ENGINEERING, PROCUREMENT AND CONSTRUCTION OF 13.5 MW CHAPARE CHARKHIL HYDROPOWER PROJECT DISTRICT KURRAM.

Addendum No. 1.

Replies to queries of Pre-Qualified Contractors JV in the light of Pre-bid meeting held on 3rd April, 2023 in the committee Room of PEDO under the Chairmanship of Chief Executive Officer, PEDO.

| PROJECT LAND ACQUISITION INDEX PLAN | | |

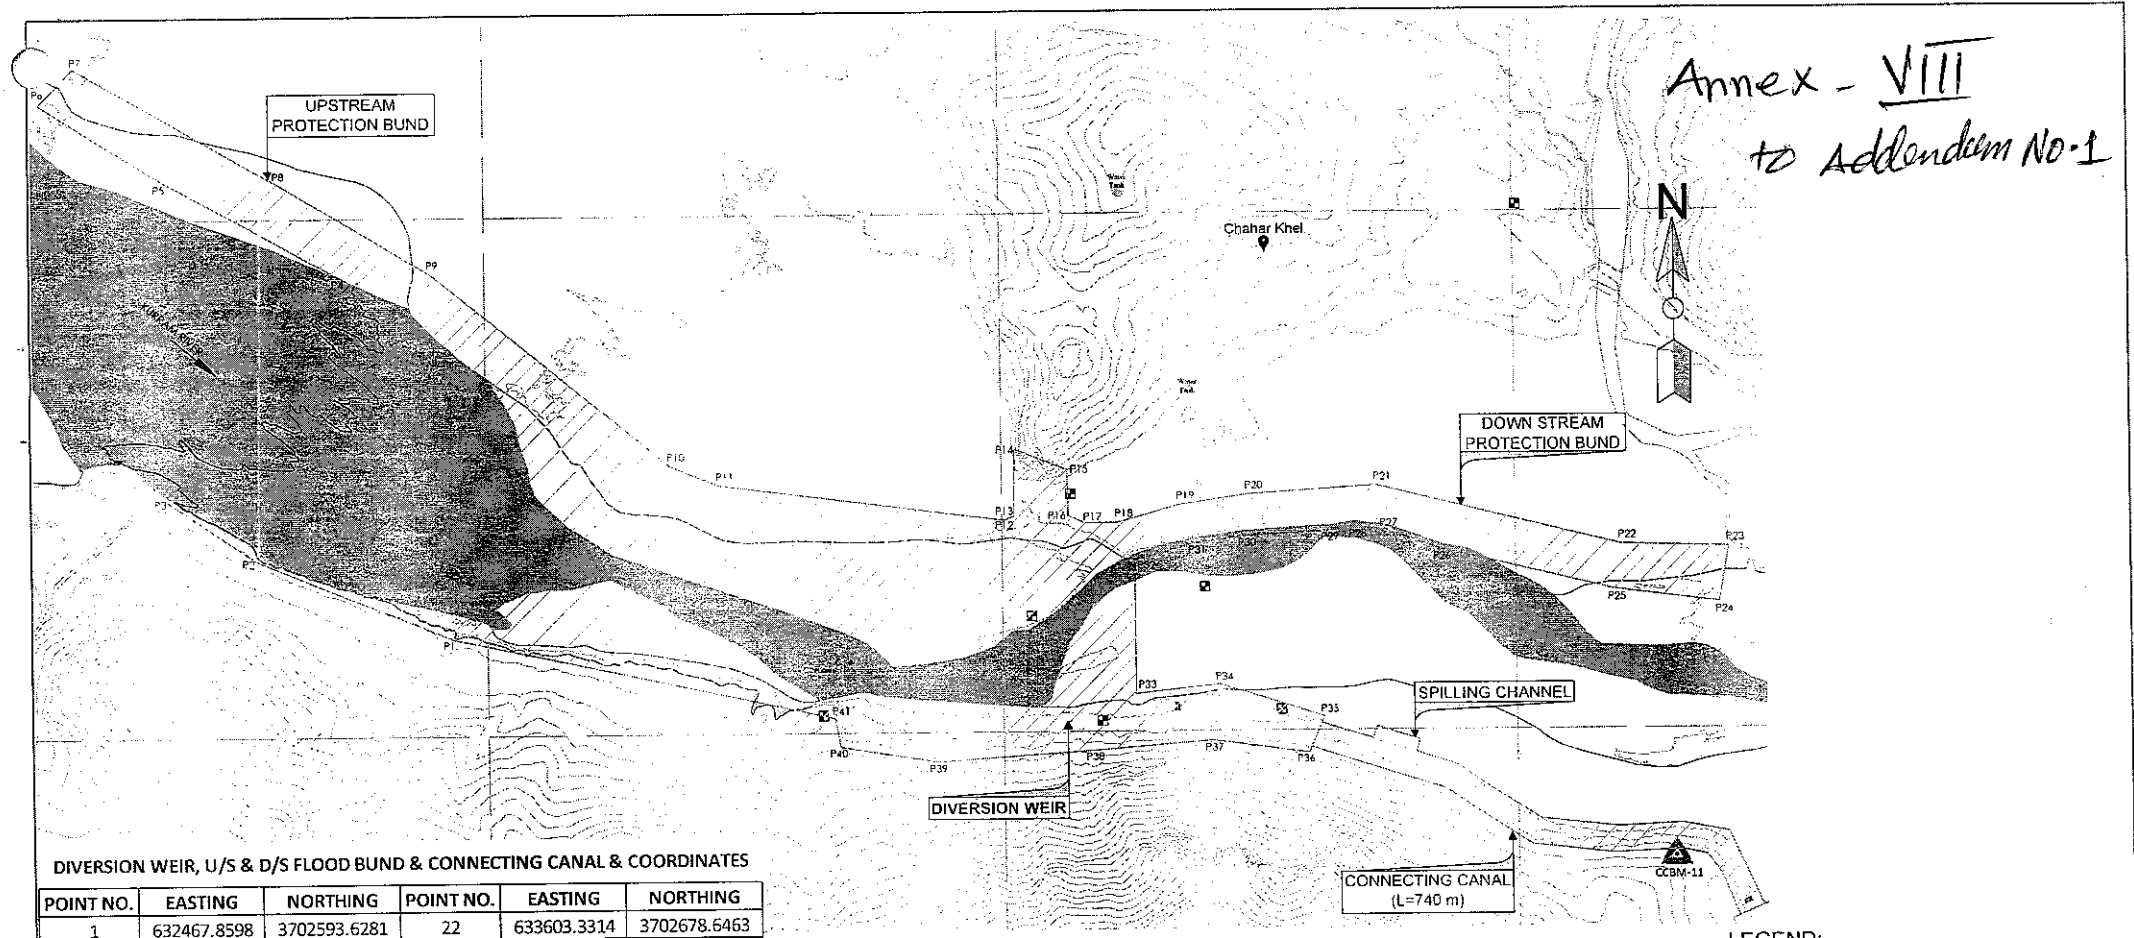
| Addendum No. 1. | | | |
|---|---|--|---|
| 55 | Land Acquisition Drawing: (Tender Drawings) | Please provide Land Acquisition drawing. | Agreed To the list of tender drawings, the following drawing for land acquisition are added as (Annex-VIII) to Addendum No.1: |

| Addendum No. 1. | | | |
|---|--|--|--|
| | | | (1) Drawing No CCKHPP- 000 (Project Land Acquisition Index Plan) (2) Drawing No CCKHPP- A (Project Land Acquisition Plan- Diversion Weir, U/S & D/S Flood Bund & Connection Canal & Coordinates) (3) Drawing No CCKHPP- B (Project Land Acquisition Plan- Sediment Basin & Headrace Canal -I) (4) Drawing No CCKHPP- C (Project Land Acquisition Plan- Headrace Canal-II,III,IV. Plan and Coordinates) (5) Drawing No CCKHPP- D (Project Land Acquisition Plan Forbay, Spill Channel, Penstock, Power House, Tailrace & Colony Plan, Plan & Coordinates) |

| REV. NO. | DATE | DESCRIPTION OF REVISION |
|---------------------------------------|--------------------------------------|---|
| AQUEDUCT TYPICAL PLAN & SECTION | | |

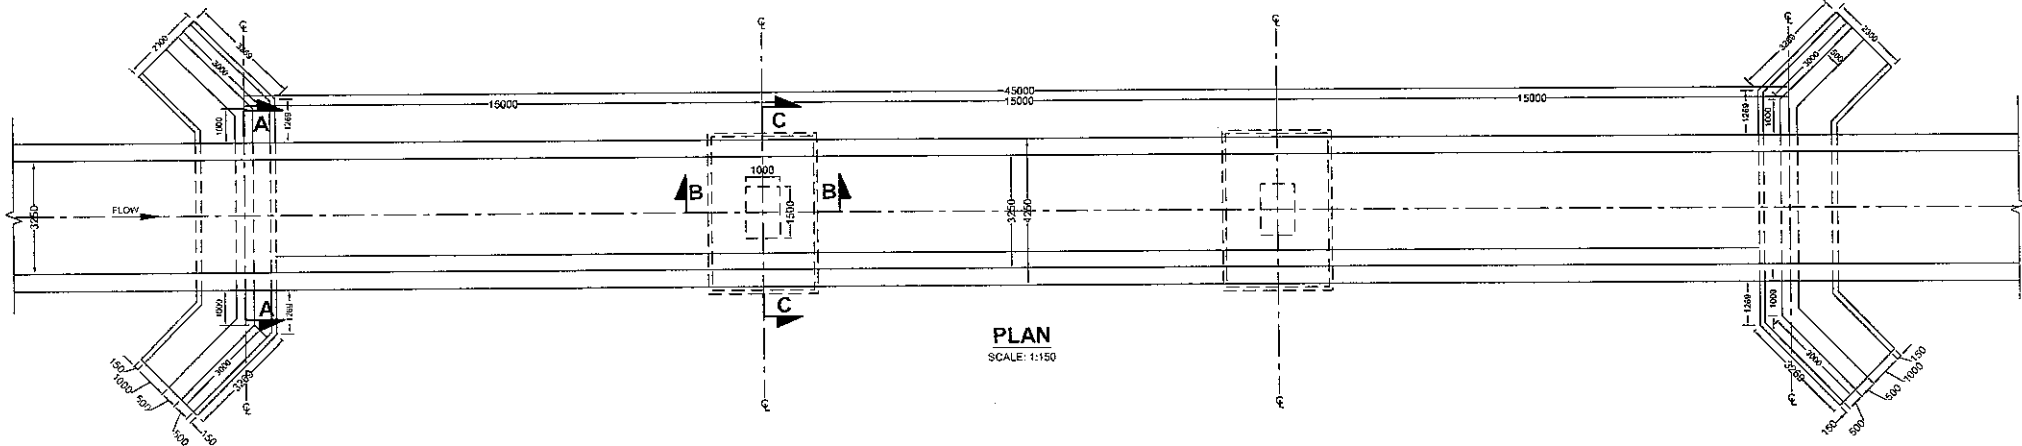
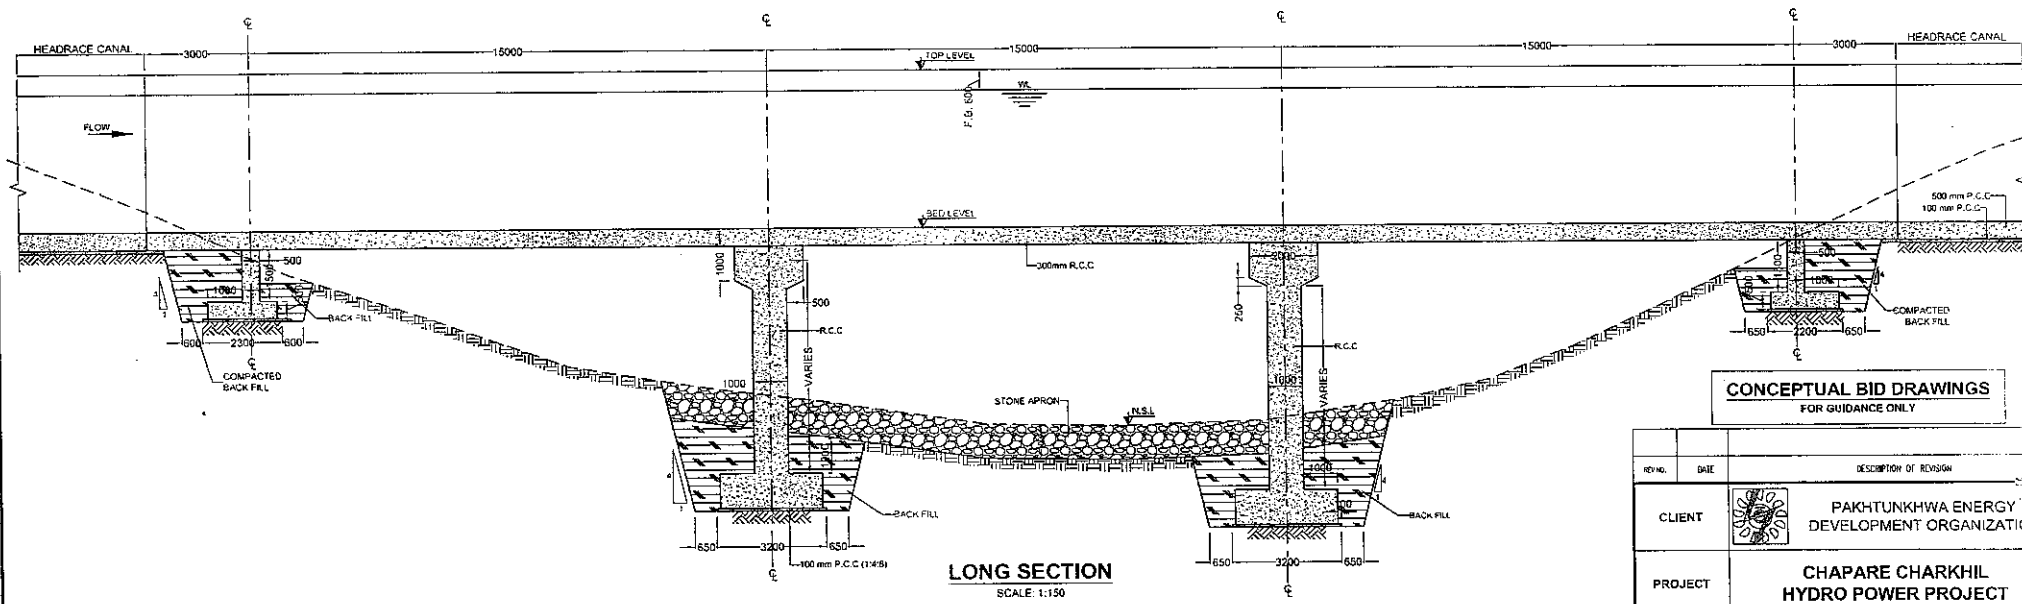
| Addendum No. 1. | | | |
|---|--|--|--|
| 56 | Aqueducts: (Tender Drawings) | We have neither found the drawings of Aqueducts in the list of Drawings nor any detail about sizes / dimensions or other detail in the attached drawings, although the Aqueducts I, II, III & IV are shown on the Project Layout Plan (drawings No. CCKHPP - 031 & 032). | To the list of drawings, the following drawings are added as (Annex-IX) to Addendum No.1. (1) Drawing NO CCKHPP-156 (Aqueduct Typical Plan & Section). (2) Drawing NO CCKHPP-157 (Aqueduct Typical Plan & Section). |

| REV. NO. | DATE | DESCRIPTION OF REVISION |
|---|--------------------------------------|---|
| FOOT BRIDGE TYPICAL PLAN & SECTION | | |

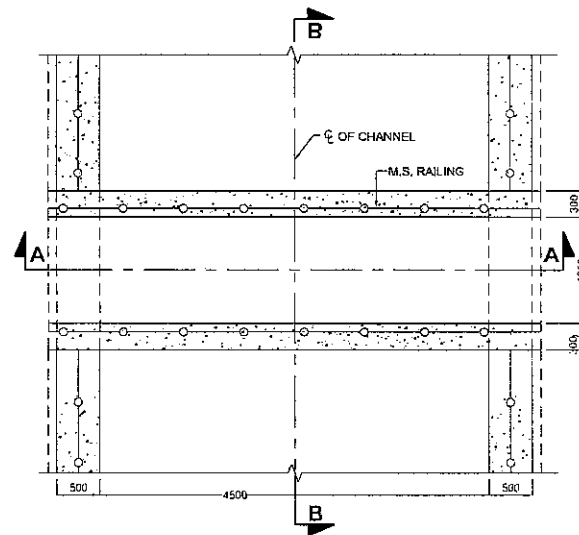
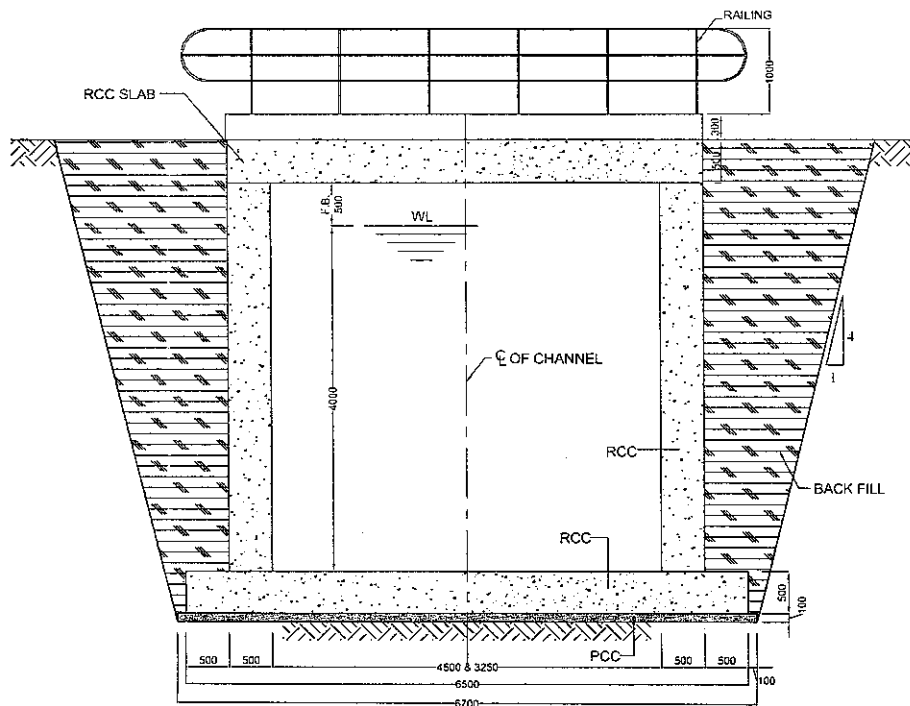
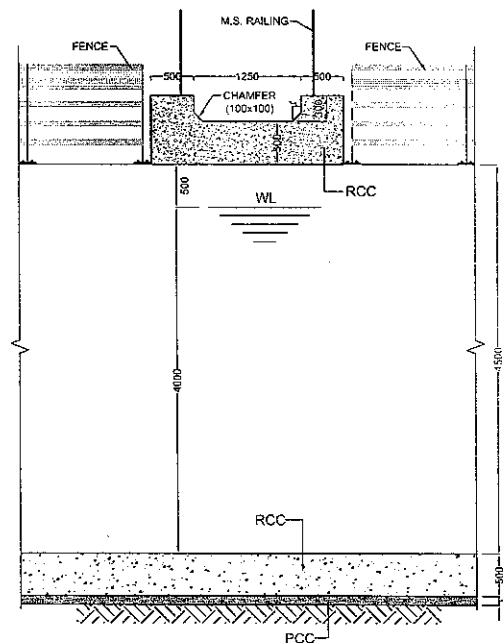
| S.NO | Biding Documents Reference | QUERIES | PEDO Replies/Clarifications |
|------------------------|------------------------------------|--|--|
| 57 | Foot Bridges: (Tender Drawings) | Similarly, the Foot Bridges I & II are mentioned on the drawings (CCKHPP - 071) but sizes / dimensions are not found in the issued drawings. | To the list of drawings, the following drawings is added: (1) Drawing NO CCKHPP-151 (Foot Bridge) (Annex-X) to Addendum No.1. |
